Planning & Regulation Committee Monday, 10 December 2018

ADDENDA

PN6. Proposed extraction of mineral and restoration by infilling with imported inert materials to agriculture on land to the south east of Shipton on Cherwell Quarry - Application No. MW.0046/18

Revised bund layout - Option 2

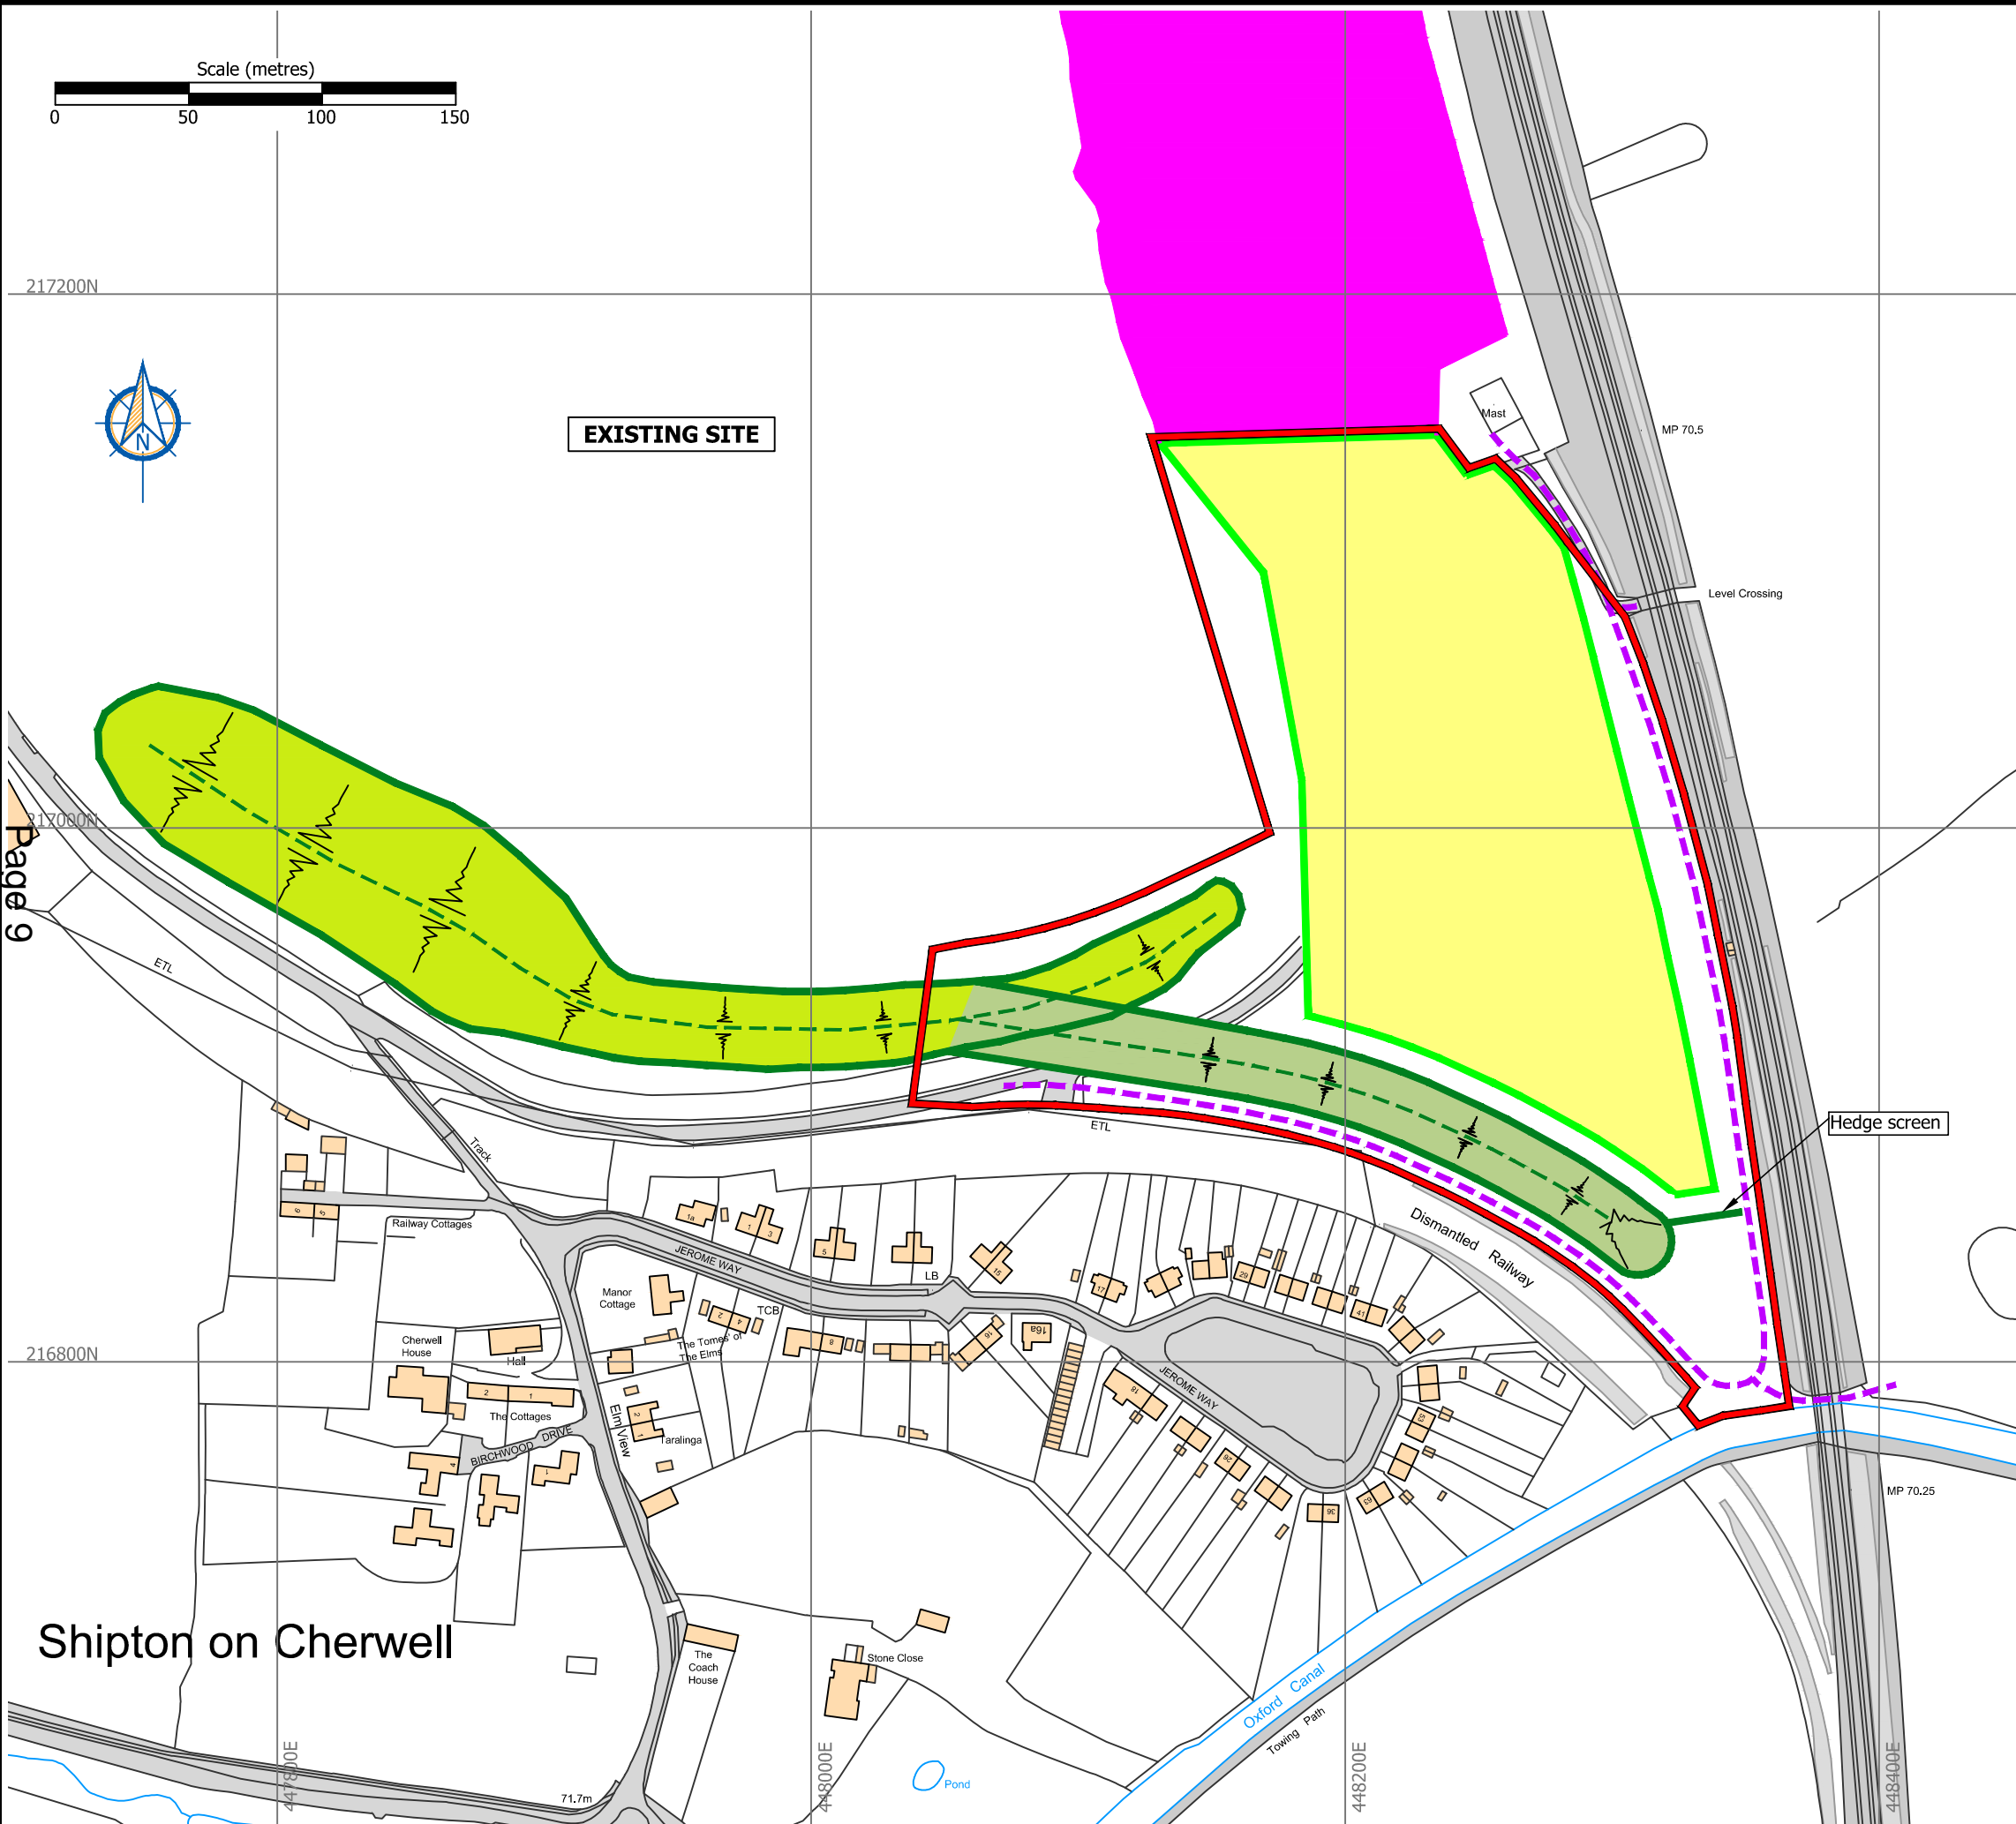
3. Asking whether I am going to update the committee following a meeting we had with the airport.
4. The report refers to the bund being 5m in paragraph 29 and 108, which may confuse members.

5. The committee plan includes the canal and footpath within the red line which is incorrect and misleading.
6. Thinks that the statement Annex 1 of the report that “Paragraph 4.44 of the OMWCS contradicts policy M2 of the OMWCS” is not what was stated within the Need Assessment. Makes the point that the first sentence of paragraph 4.44 should not be taken out of context and should be read as a whole as it goes on to say that monitoring is required to demonstrate that the increasing sales is an ongoing trend. Further makes the point that the supporting text does not override policy, but adds clarity.

5. The height of the bund has been reduced to 4m, and so where the bunds are referred to as 5m in height in paragraphs 26, 29 and 108 this is corrected. This does not alter the officer view on the visual impact of the bund on the local amenity of residents as discussed in the report

6. For clarity, this application site does not include the canal or towpath. The application red line plan is attached to this addendum.
7. I agree that the first sentence should not be taken out of context and that it provides clarification, but cannot overrule the policy. For information the full paragraphis:
